APPLICATION OF TEXAS UTILITIES
GENERATING COMPANY, ET AL. FOR
AN OPERATING LICENSE FOR
COMANCHE PEAK STEAM ELECTRIC
STATION UNITS #1 AND #2
(CPSES)

Docket Nos. 50-445
and 50-446

TESTIMONY OF CASE WITNESS
MARK A. WALSH

FIGURE 3.7B-1

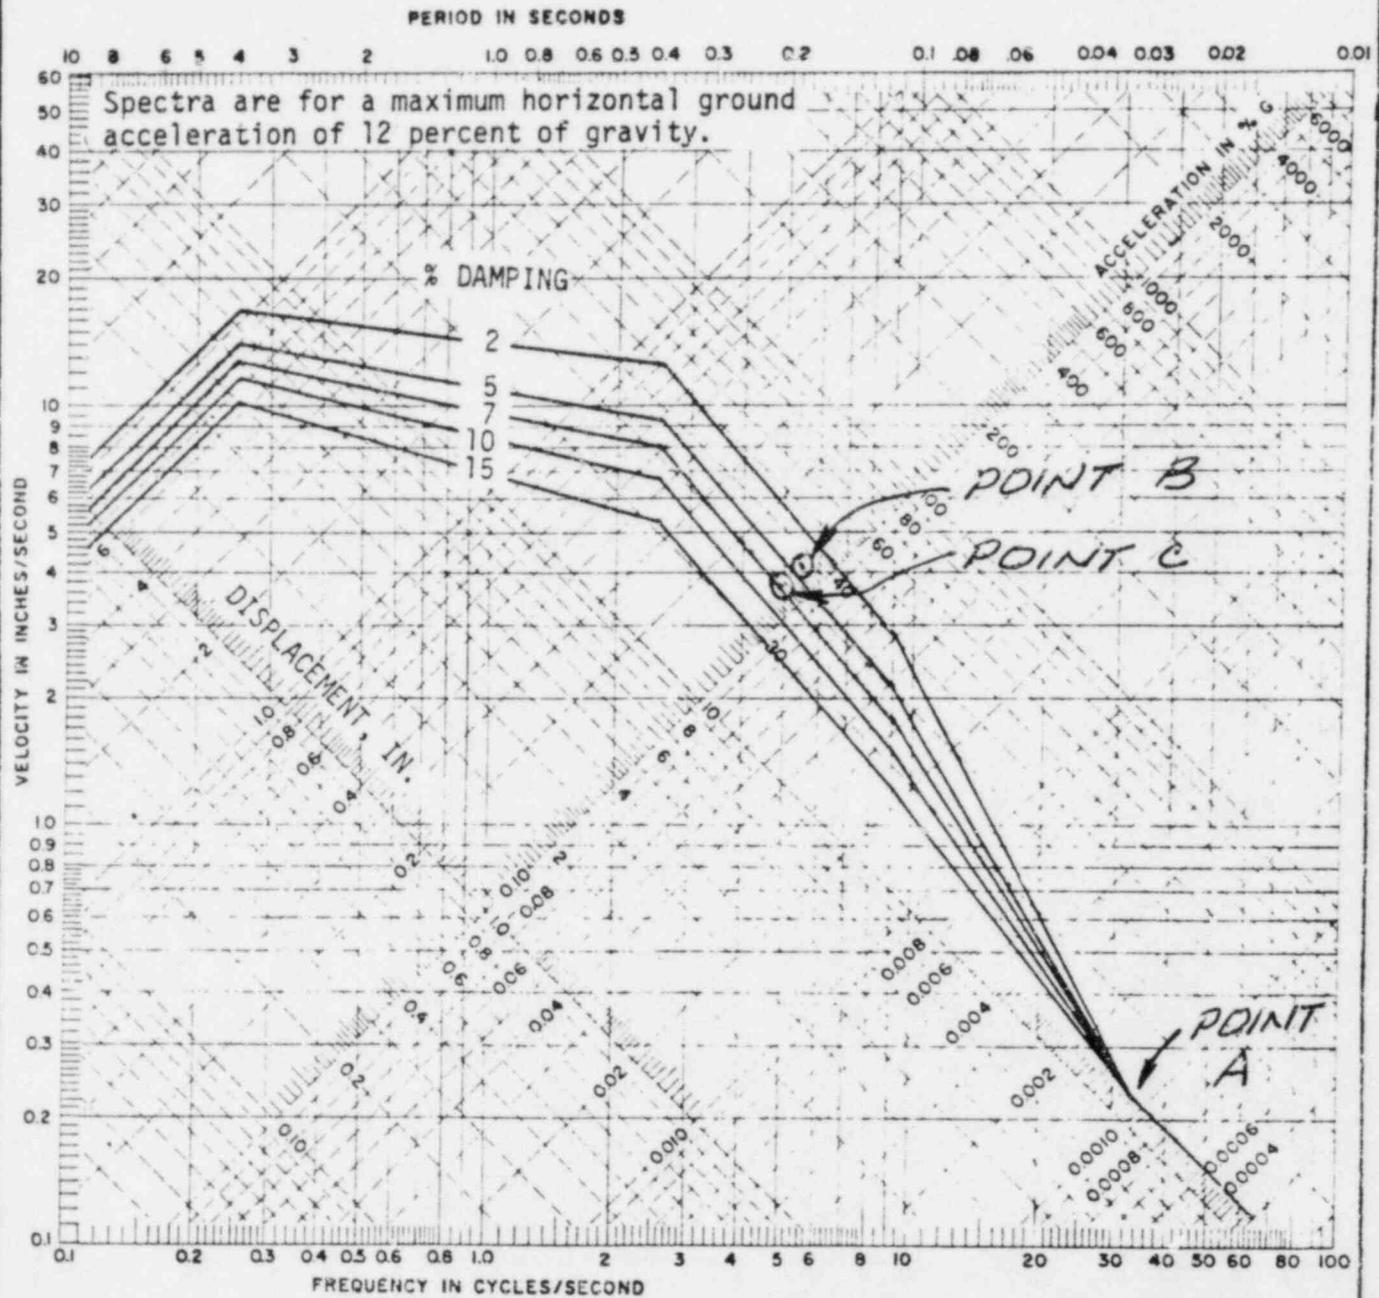
8 The increase in damping, CYGNA refers to, has a small effect compared
9 to the effect caused by the change in the natural frequency. In table 3.7B-1
10 of the FSAR, the damping for welded structures under SSE is 4% and for bolted
11 structures the damping is 7%. The 7% damping is considering all bolted con-
12 nections in a frame, not just the base plate. To consider the effects of
13 an increase in damping, one should review a response spectra curve.

14 Figure 3.7B-1 from Applicants' FSAR (Applicants' Exhibit 3), copy attached
15 as Attachment A hereto, is a response spectra curve of the SSE, located at
16 the ground elevation. Elevations higher than the ground elevation will exhibit
17 higher accelerations. The type of structure (i.e., concrete or steel) will
18 also play an important part in the accelerations at different elevation within
19 the building. Since the response spectra curve shown in Figure 3.7B-1 is
20 for ground acceleration, an item completely rigid will exhibit the same ac-
21 celeration as the ground, and for the response spectra curve, the value is
22 12% of gravity. An item can be considered rigid when its natural frequency
23 is 33% as shown as what I have indicated as Point A (see Attachment A).
24 One will note, damping plays no part in the acceleration when a support is
25 rigid. Note also, the displacement for a rigid support is less than .0015

2 The load which causes the displacement is from the weight of the support
3 and the tray with its contents. The weight is in the horizontal direction
4 and is actually the mass times the acceleration due to gravity that is contri-
5 buting to the horizontal displacement. When a support is rigid, the seismic
6 acceleration it will experience is .12 g's at ground level, and this is in-
7 dependent of damping.

8 Now consider a support that displaces 1/8 of an inch (.125 inches) using
9 4% damping its horizontal acceleration at ground level is 35% of gravity, as
10 indicated on Attachment A as point B. With 7% damping, its horizontal accelera-
11 tion would be 28% of gravity. It is apparent that the higher damping will
12 produce smaller seismic loads. But equally apparent is the acceleration
13 from a rigid condition equalling 12% of gravity goes to 28% of gravity with 7%
14 damping, in essence the seismic load will double.

15 As has been demonstrated above, a 1/8 inch displacement makes a significant
16 difference on seismic loads. CYGNA's comment "Plate slippage will increase
17 damping and thereby lower applied seismic loads" is unfounded. Although the
18 Applicants may have increased the dead weight by 17.5% on some frames, this
19 is quickly offset by the exclusion of the frames' self weight excitation and
20 the neglect to consider the effects of oversized holes as well as the other
21 items not included in the original analysis.
